PRODUCT / PROCESS CHANGE INFORMATION

1.1 Company		STMicroelectronics International N.V
1.2 PCI No.	ADG/18/10840	
1.3 Title of PCI	TO-3P Marking Traceability Change - SP Semi (Korea)	
1.4 Product Category	Power MOSFET, IGBT, Power BIPOLAR	
1.5 Issue date	2018-04-11

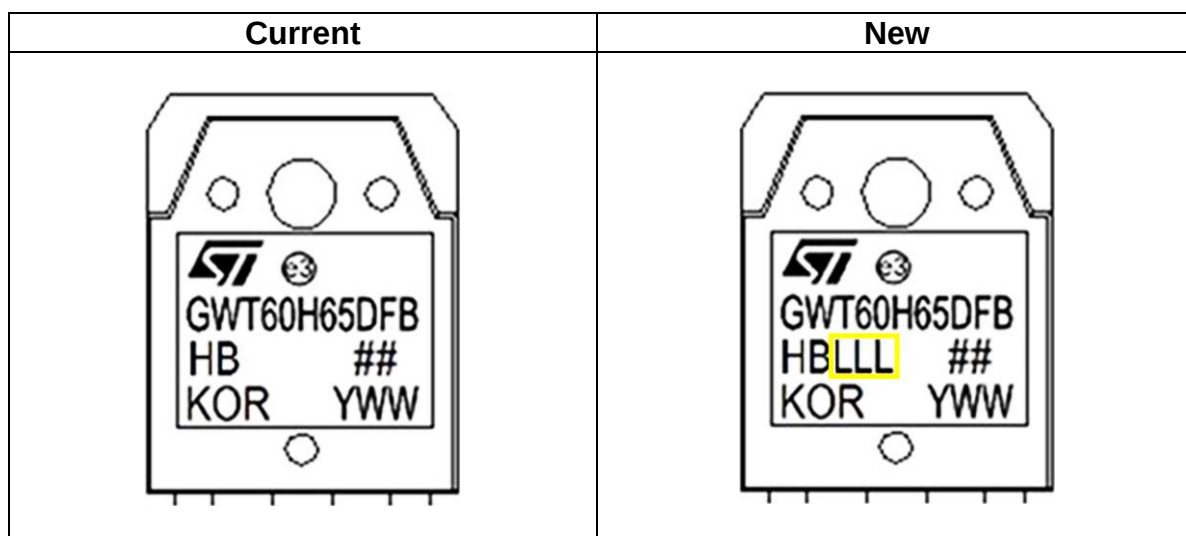
Please be informed that we are going to change the Marking Traceability of the TO-3P package of STMicroelectronics, manufactured in our Subcontractor SP Semi (Korea).
The change consists of three additional digits highlighted in the following NEW example.
